STAFF REPORT
COMMUNITY DEVELOPMENT DEPARTMENT

HEARING DATE: 3/3/2022
 TO: Planning & Zoning Commission
 FROM: Joe Dodson, Associate Planner
 208-884-5533
 SUBJECT: H-2022-0001
 Pinedale Subdivision

Annexation and Zoning of 1.22 acres of land with a request for the R-15 zoning district and a Preliminary Plat for 12 building lots and 2 common lots on 1.22 acres in the requested R-15 zoning district, by Pine Project, LLC.

ANNEXATION EXHIBIT B

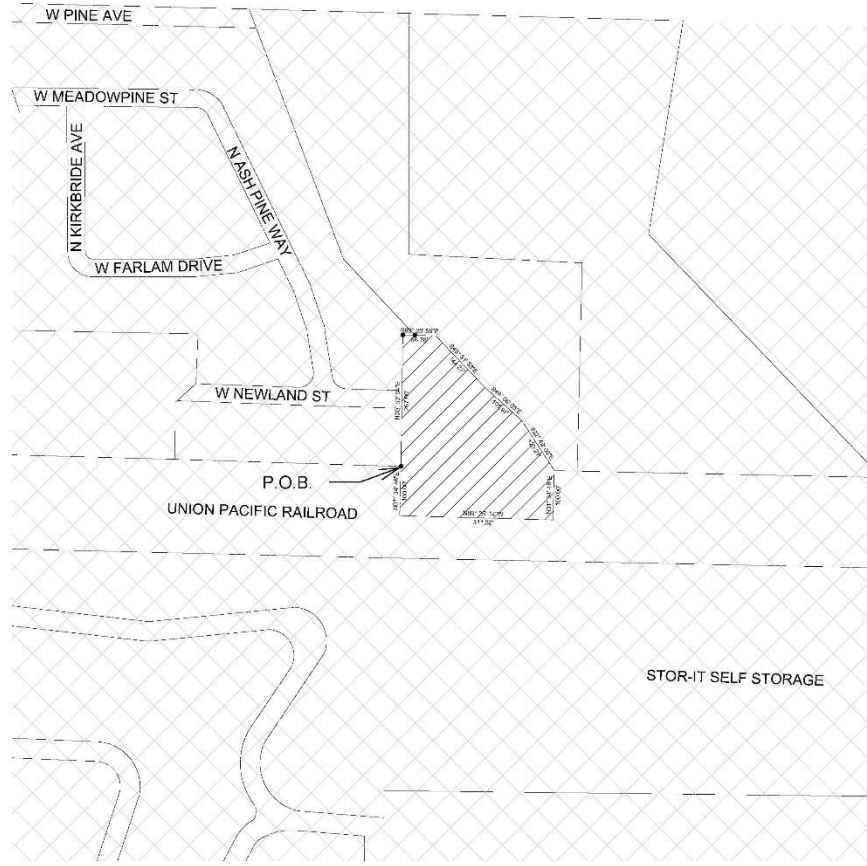
NOTE: Upon application submittal and initial review, there was miscommunication between Staff and the Applicant and the Applicant was required to revise the Annexation boundary to include area that is already annexed into the City (within the railroad right-of-way). There is no need to rezone this area in conjunction with this annexation so Staff is recommending the Applicant submit a revised Annexation and Zoning legal description and exhibit map that encompasses only the area not currently annexed and matches the plat boundary.

2. Prior to the City Council hearing, the Applicant shall provide revised Annexation and Zoning legal description and Exhibit Map to exclude the railroad right-of-way area.

B. Preliminary Plat (dated: 2/21/2022)

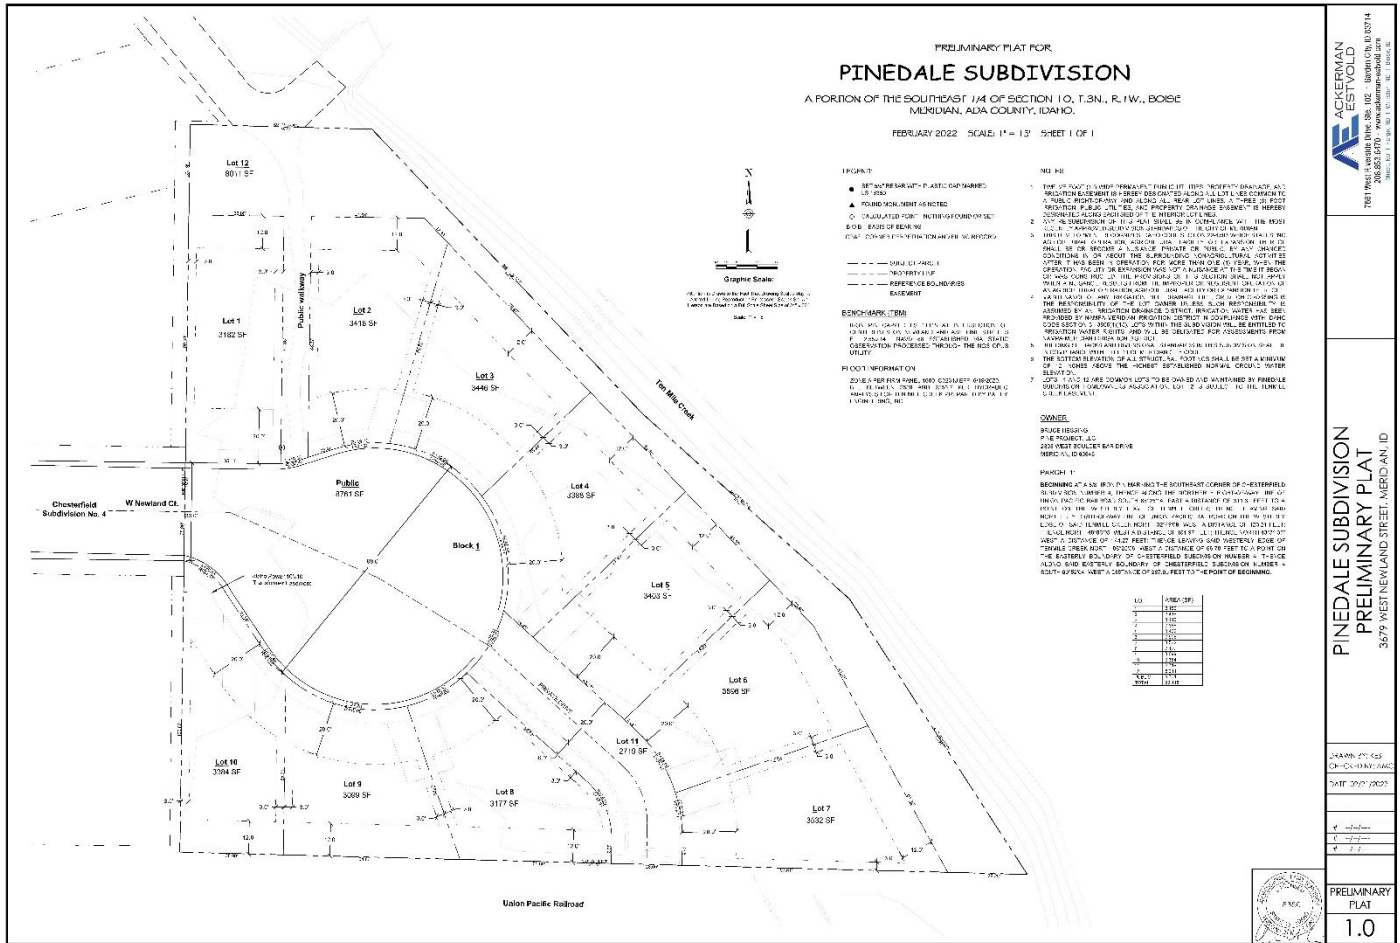
The residential lots appear to meet all UDC dimensional standards per the submitted plat. In addition, all subdivision developments are also required to comply with Subdivision Design and Improvement Standards (UDC 11-6C-3). *The proposed preliminary plat and submitted plans appear to meet all UDC requirements except for the number of lots taking access from a common drive. Per UDC 11-6C-3D, no more than three (3) lots can take access from the same side of a common drive and the proposed plat depicts four (4) lots taking access (Lots 4-7) from the common drive because of Staff’s recommendation to have shared driveways where possible. The Applicant will be required to show Lot 4 taking access from the cul-de-sac instead of showing it shared with Lot 5 and on the common drive.*

living setback is 10 feet while the garage setback is 20 feet; this allows for more buildable area than is shown on the submitted plat (i.e. specifically for Lots 3, 4, and 9). Staff is recommending a specific DA provision to require a number of shared driveways and to help mitigate this potential issue. However, Staff notes the building lots may not be wide enough to accommodate the required parking pad for side-loaded garages. The Applicant should work to mitigate these issues and revise the plat accordingly.

Furthermore, the landscape plan appears to show solid fencing along the east property line of Lot 8, abutting the proposed common drive. According to UDC 11-6C-3D.5, if solid fencing is proposed abutting a common drive, at least 5-feet of landscaping is required between the common drive and the buildable lot. The latest preliminary plat does not appear to comply with this but the landscape plan does show landscaping. So, the Applicant should clarify which plan is accurate AND revise the landscape plan to show the proposed fencing type. According to the document provided by the Parks Department, the required pedestrian easement for a future connection from the south boundary to the north boundary of the subject site can overlap the common drive and essentially utilize the common drive as the pathway. This would allow for the required 5 feet of landscaping on the west side of the common drive adjacent to Lot 8 to allow for solid fencing.

3. The preliminary plat included in Section VII.B, dated February 21, 2022, shall be revised as follows prior to the City Council hearing, except as noted:

- a. Show the entrance to the open space lot (Lot 12) containing the micro-path lot to be at least 15 feet wide, per UDC 11-3A-8 standards.
 - b. Lot 4 shall take access from the cul-de-sac and not from the common drive in accord with UDC 11-6C-3.

- c. Prior to the Commission hearing, the applicant should graphically depict the Tenmile Creek easement on the plat and contact NMID to determine if any encroachment would be allowed in the easement. IF encroachments are allowed, staff recommends the applicant provide an exhibit that demonstrates how homes on these lots would comply with NMID requirements.

1) Land Scaple plan
1" = 20'-0"

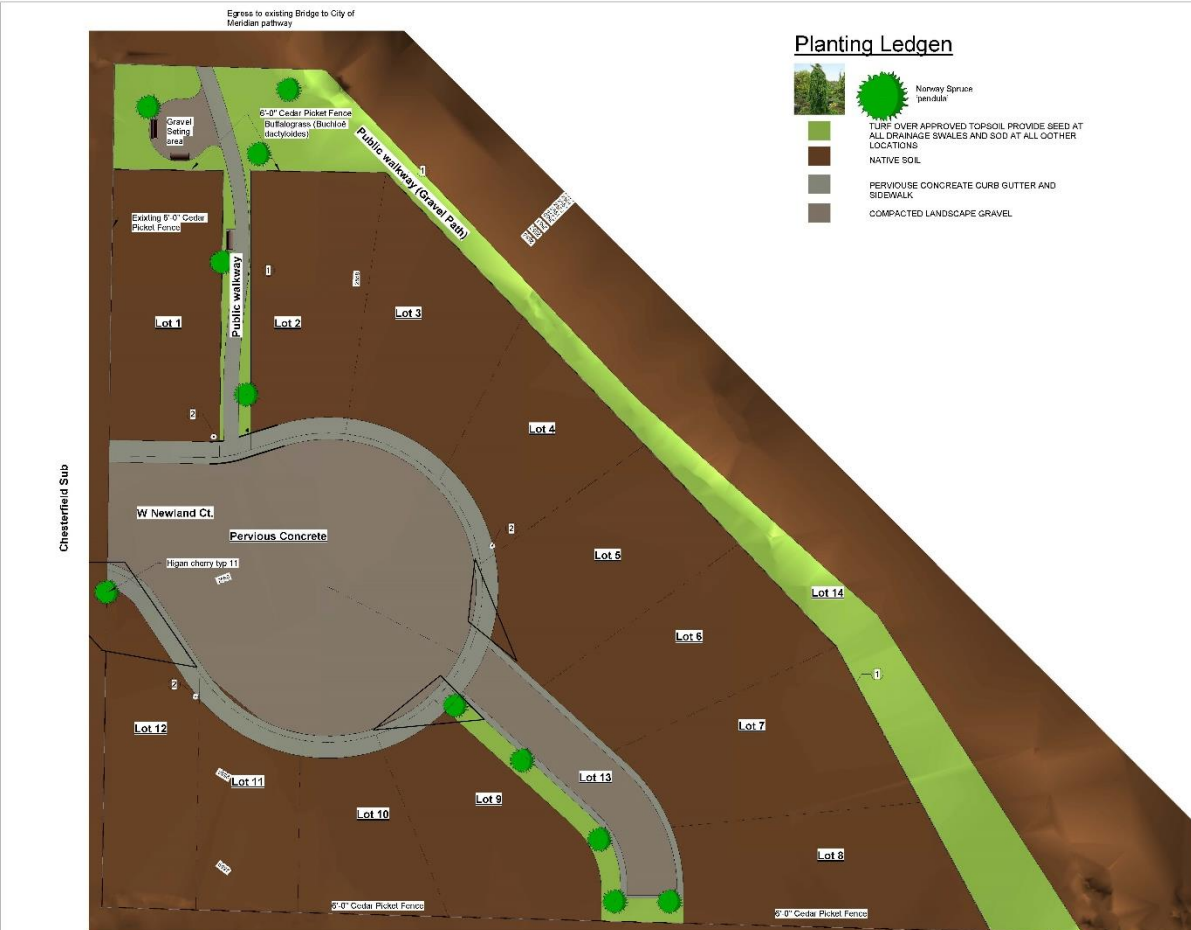
The required landscaping regulated by code within the proposed development is the common open space and micro-path areas around the north and eastern perimeters. The submitted landscape plans shows landscaping in these areas as proposed but does not match the latest plat. The Applicant should update the landscape plan prior to the City Council hearing.

The Applicant is proposing the micro-path lot as 10-feet wide instead of the required 15-foot minimum but is currently shown with two trees abutting the path, exceeding code due to its length being approximately 100 feet (trees are required at the ratio of 1/100 linear feet, per UDC 11-3B-12). Furthermore, this micro-path lot opens up to a common open space area shown with a seating area, grass, and a few trees for shade. This landscaping shows compliance with code requirements for the number of trees and other vegetative ground cover for common open space.

All fencing is required to comply with the standards listed in UDC 11-3A-7 and 11-3A-6. Fencing is proposed as shown on the landscape plan and does not meet UDC standards.

6-foot tall wood fencing is proposed through the site despite being adjacent to common open space areas that are tucked away and adjacent to an open waterway, the Tenmile Creek. With the final plat submittal, the Applicant should revise the landscape plan to show open-vision fencing

or semi-private open vision fencing along the rear property lines of Lots 1-7 and the side property lines abutting the micro-path lot for Lots 1 & 2. In addition, the Applicant should clarify if any fencing is proposed along the Tenmile Creek and coordinate with Nampa Meridian Irrigation District on where they would like any fencing located within their easement.

4. The landscape plan included in Section VII.C, dated August 3, 2021, shall be revised as follows prior to submitting for Final Plat approval:
 - a. Revise the plan to match the latest preliminary plat.

- b. Lot 12, Block 1 shall be a minimum of 15-feet wide and landscaped in accord with UDC 11-3B-12.
 - c. If solid fencing is proposed on the east property line of Lot 8, show the required 5 feet of landscaping between the property line and the common drive (Lot 11) in accord with UDC 11-6C-3D.
